ISSUE: Certificate of Appropriateness for alterations (after-the-fact)

APPLICANT: Van Soderberg and Megan Dolan

1308 Oronoco Street

BAR CASE# _____BAR2025-00329

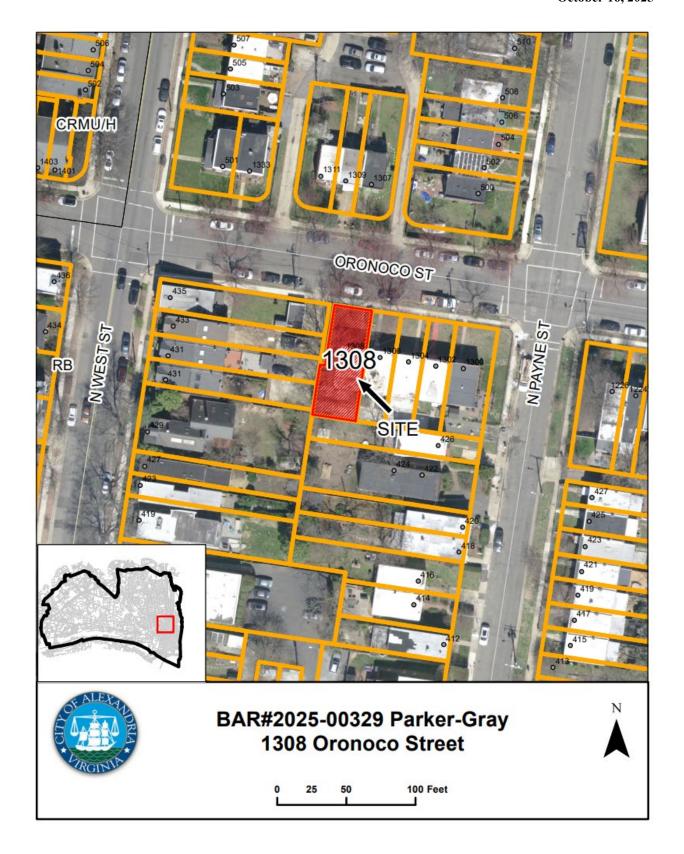
Based on the *Design Guidelines* and Zoning Ordinance review standards, staff finds that the vinyl fence uses an inappropriate material and is not in keeping with the surrounding block face. The use of vinyl as a fence material detracts from the architectural character of both the subject property and block, and if approved by the Board would set a negative precedent for the neighborhood. Staff therefore recommends **denial** of the Certificate of Appropriateness for alterations.

Staff recommends denial of the Certificate of Appropriateness for alterations.
